Access Compliance Report Public Rights-of-Way (Curb Ramps)

Intersection ID: 17443 Main Street: E_EXMORE_ST **Cross Street: OLD PINEVILLE RD** Location: NW ADA ID: 1D4D0E2E2083 Ramp Type: PerpDiag Initial Pass/Fail: Fail **Overall Compliance: No Severity Score:** 25

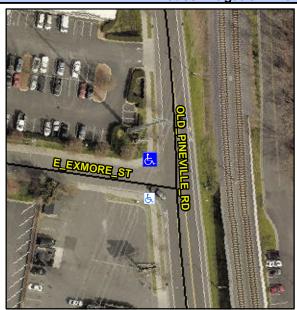
Field Measurements/Component Compliance						
	Compliance Description		Data	Comp	liance Description	Data
	N/A	Ramp Length (in)	103.0	No	Ramp Slope (%)	15.3
	Yes	Ramp Width (in)	48.0	Yes	Ramp XSlope (%)	0.3
	N/A	Flare Type LT	N/A	N/A	Flare Type RT	N/A
	N/A	Flare Slope LT (%)	N/A	N/A	Flare Slope RT (%)	N/A
	N/A	Flare Traversable LT?	N/A	N/A	Flare Traversable RT?	N/A
	N/A	Landing Length (in)	N/A	N/A	DWS Provided?	N/A
	N/A	Landing Width (in)	N/A	N/A	DWS Contrast?	N/A
	N/A	Landing Slope (%)	N/A	N/A	DWS Length (in)	N/A
	N/A	Landing X Slope (%)	N/A	N/A	DWS Full Width?	N/A
	N/A	Landing Curb? (Y/N)	N/A	N/A	DWS Offset (in)	N/A
	N/A	Shared Landing?	N/A			
	N/A	Gutter Ponding?	N/A	N/A	Gutter Slope (%)	N/A
	N/A	Gutter Lip Ht (in)	N/A	N/A	Gutter X Slope (%)	N/A
	N/A	Painted X Walk1?	No	N/A	Painted X Walk2?	No
		X Walk 1 Direction	To S		X Walk 2 Direction	То Е
	N/A	X Walk 1 Width (in)	N/A	N/A	X Walk 2 Width (in)	N/A
		X Walk 1 Slope (%)	2.3		X Walk 2 Slope (%)	4.8

E EXMORE ST StopSign **OLD PINEVILLE RD** None Possible Solutions: Remove & Replace Curb Ramp With **Two New Directional Ramps or** Equivalent. Surveyor Notes: N/A PROW/ADA: Not Found, R304.2.2
